*Joint Standing Committee  
on the Parliamentary Zone*

*Report relating to  
proposed works in the Parliamentary Zone*

*High Court Cooling Tower  
Baldessin 'Pears' Sculpture*

*February 1992*

ILLUSTRATION OF BALDESSIN 'PEARS'  
IN PROPOSED LOCATION AT FRONT OF  
NATIONAL GALLERY OF AUSTRALIA

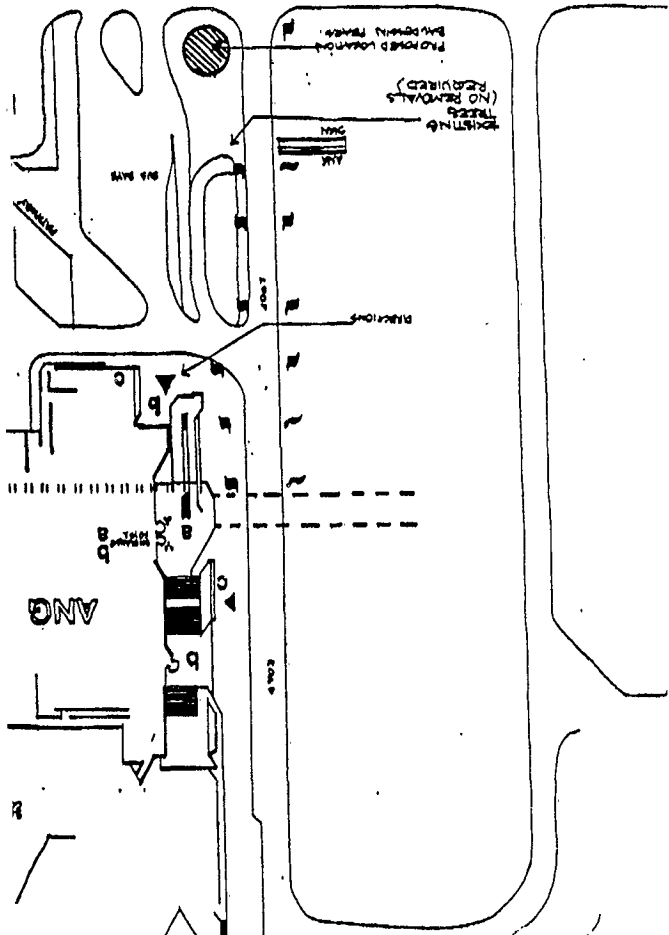
The Australian National Gallery (ANG) is seeking approval to locate the George Baldessin 'Pears' sculpture on the median strip near the access road to the ANG from King Edward Terrace (Block 7, Section 29 Parkes).

The ANG attracts up to 500,000 visitors to Canberra per annum. All market and visitor research conducted to date reveals severe problems with external directional signs, i.e. a lack of indication of the location of the ANG. The Director of the Gallery believes that the positioning of the proposed distinctive sculpture, a group of six giant pears, besides being attractive in its own right and enhancing the ambience of the surroundings, will reinforce public awareness of the Gallery and assist in alerting visitors to its location and car park area.

The National Capital Planning Authority has considered the project in detail and considers that it would be quality addition to the Parliamentary Zone.
